**SAFETY
RECALL**

SR14-02

DATE :	FEBRUARY 2014 SECTION :	23 - Accessories
SUBJECT:	LOWER WINDSHIELD WIPER MOTOR INSPECTION

FIGURE 2: WIPER MOTOR WHICH MUST BE REPLACED. THE LETTERS "SWF" ARE STAMPER ON THE GEARBOX CASING.

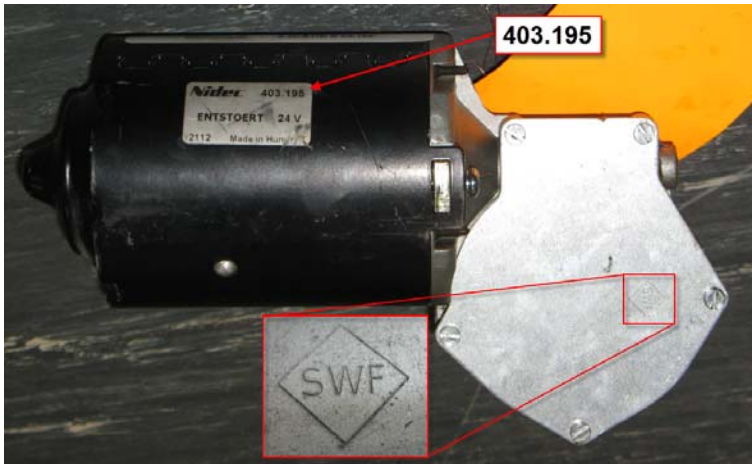
4. A wiper motor having the letters SWF stamped on the gearbox casing must be replaced. This wiper motor has also a label on which is printed the number 403 195. Proceed to the replacement of the wiper motor as described in Part 2 if the letters SWF are stamped on the gearbox casing

FIGURE 3

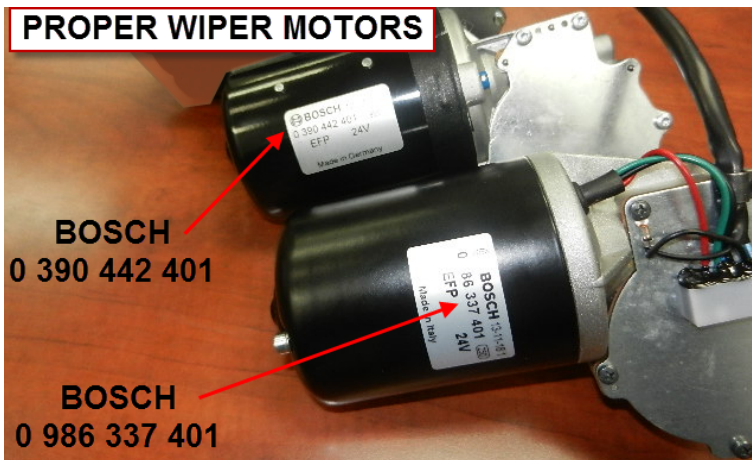
5. Proper wiper motor are identified Bosch #0 390 442 401 or #0 986 337 401. These Bosch wiper motors (Prevost part number 800328 and 800380) **do not** have to be replaced. If the wiper motor installed in your vehicle is one of these Bosch motors, no other verifications are required. This completes the campaign.
